[Docket No. FAA-2023-0922; Project Identifier AD-2022-01431-T; Amendment 39-22472; AD 2023-12-14]

Airworthiness Directives; The Boeing Company Airplanes

ACTION: Final rule.

Figure 1 to paragraph (g)(2)(i) – Fundamental Effective Isotropic PSD at Outside Interface of Aircraft Antenna

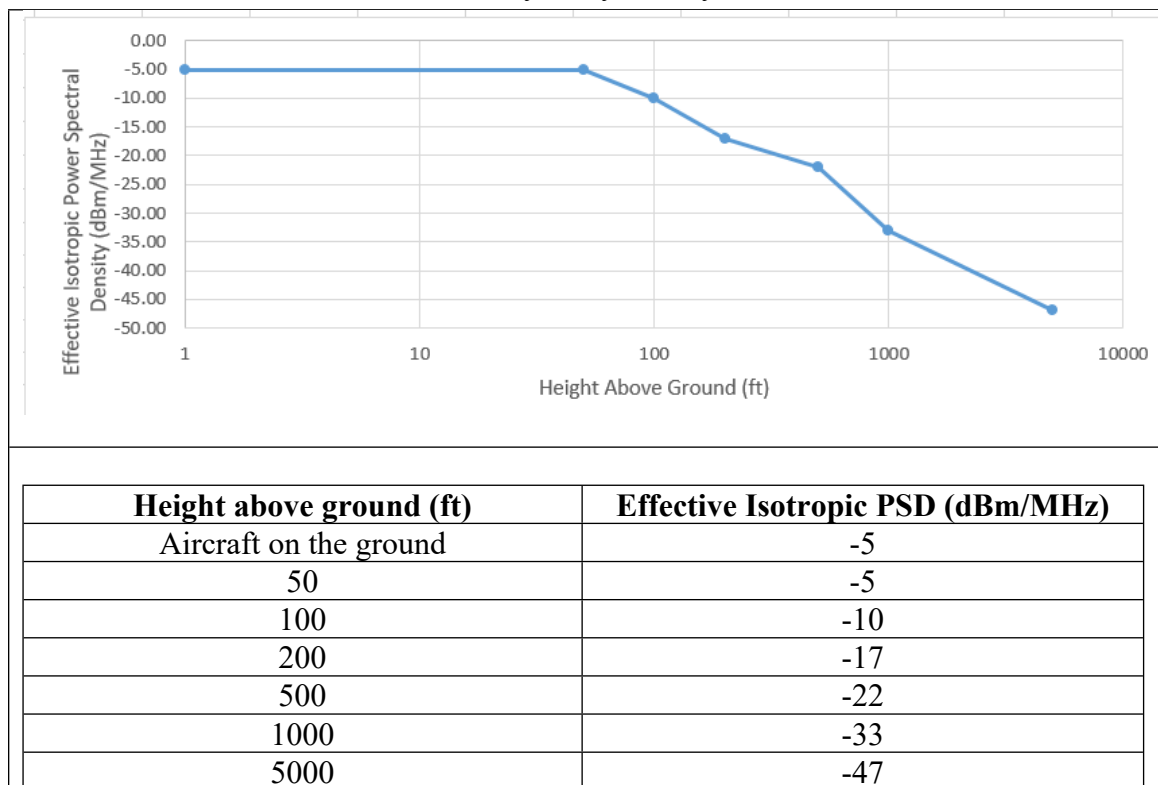
(i) Tolerance to radio altimeter interference, for the fundamental emissions (3.7-3.98 GHz), at or above the power spectral density (PSD) curve threshold specified in figure 1 to paragraph (g)(2)(i) of this AD.

Figure 2 to paragraph (g)(2)(ii) – Spurious Effective Isotropic PSD at Outside Interface of Aircraft Antenna

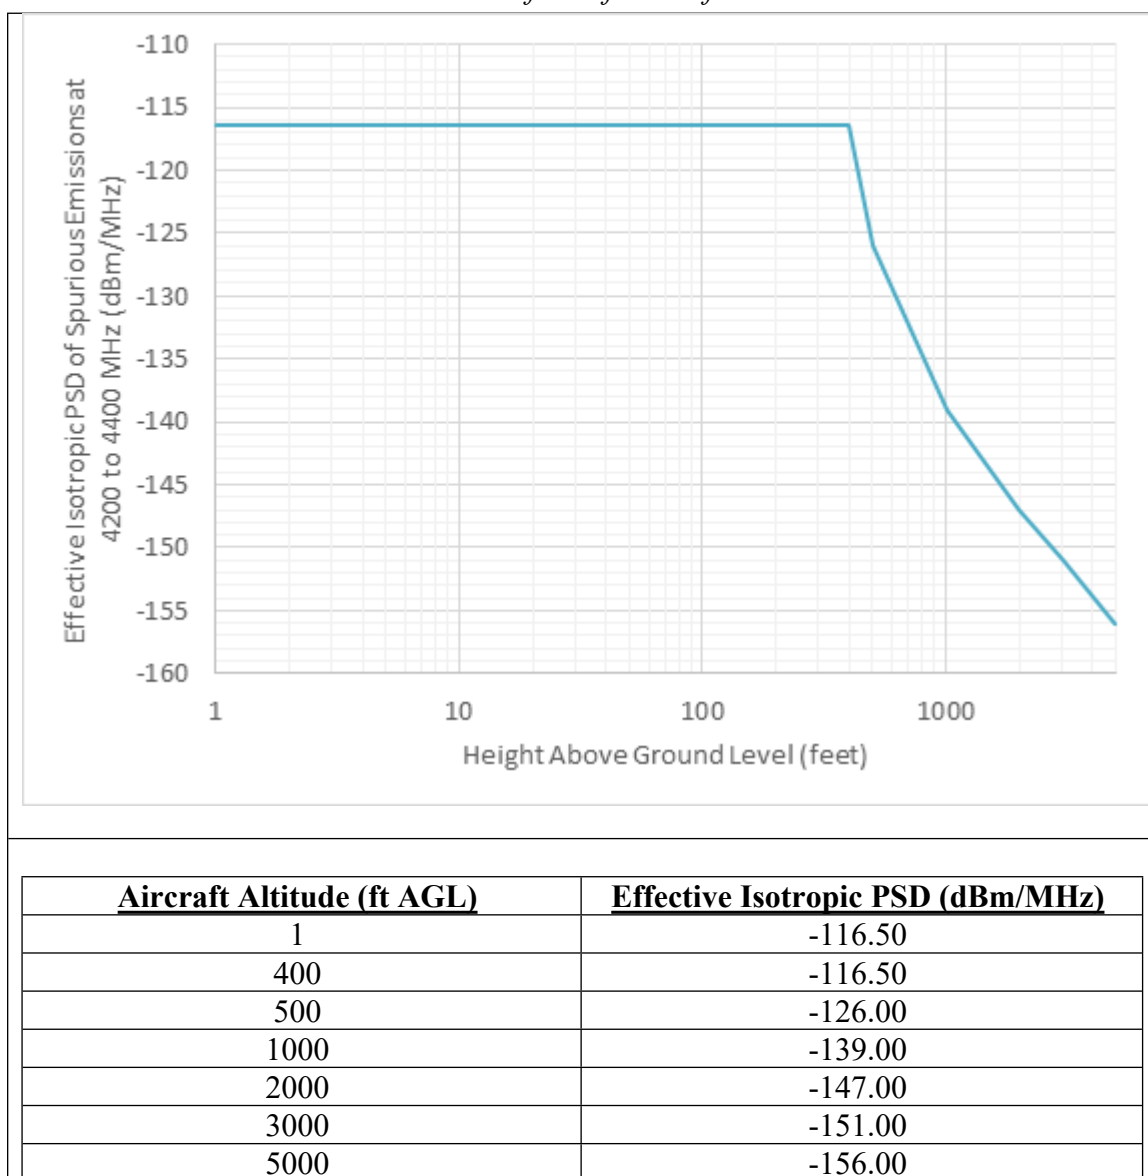
(ii) Tolerance to radio altimeter interference, for the spurious emissions (3.7-3.98 GHz), at or above the PSD curve threshold specified in figure 2 to paragraph (g)(2)(ii) of this AD.
